MAGADH AMRAPALI AREA
AKASHDEEP BUILDING
PO- DAKRA, RANCHI, JHARKHAND
CENTRAL COALFIELDS LIMITED
 (Govt. of India Undertaking)

Sub: - Submission of Point wise compliance of EDS raised in respect of Magadh East OCP on 19.04.2021.

Ref:- FP/IH/MIN/87235/2020

Released forest land

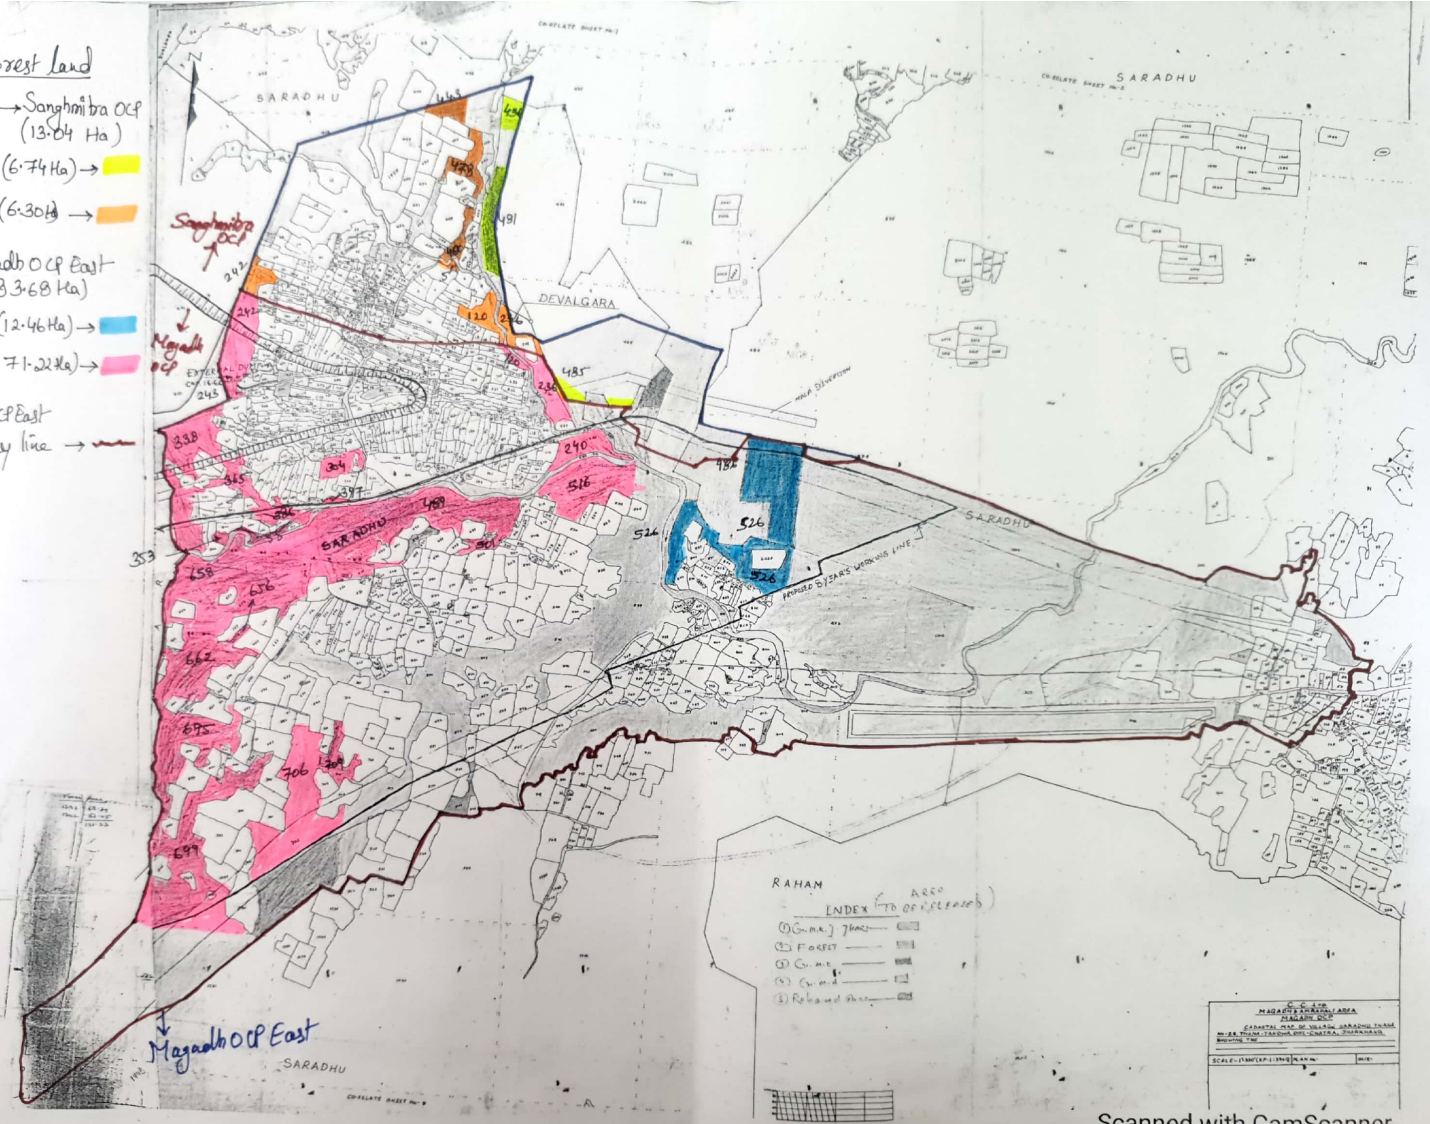
SNo.	Point No.	Remarks	Compliance																													
1	Addition al Informat ion -	Proposal uploaded previously for Magadh OCP Land released is 96.72 - ha. Applied forest land is 192.36 ha . Total Forest land = 289.08 ha. Non forest land + Applied forest area + forest land with earlier diverted forest i.e. 219.88 ha + 192.36 ha + 96.72 ha = 508.96 ha. Therefore total mining lease should be 508.96 ha. But it is mentioned as 495.92 ha. Difference is	The current forest proposal is for diversion of forest land in respect of Magadh East OCP. It includes 192.36 Ha forest land and 219.88 Ha non forest land thus the total land comes out to 412.24 Ha. Land details:

coming as 13.04 ha. Please explain.	application and 83.68 Ha of already diverted forest forest proposal i.e 96.72 Ha. The difference of 13.04 Ha (96.72 Ha - 83.68 Ha) is now included in Sanghamitra OCP the sister colliery of Magadh OCP. The plan is enclosed herewith.
--	--	-------------------------------------	--

- 96.72 Ha → Sanghmitra OCP (13.64 Ha)
- Forest (6.74 Ha) →
- Omaji (6.30 Ha) →
- Magadh OCP East (83.68 Ha)
- Forest (12.46 Ha) →
- Omaji (71.22 Ha) →
- Magadh OCP East Boundary line →
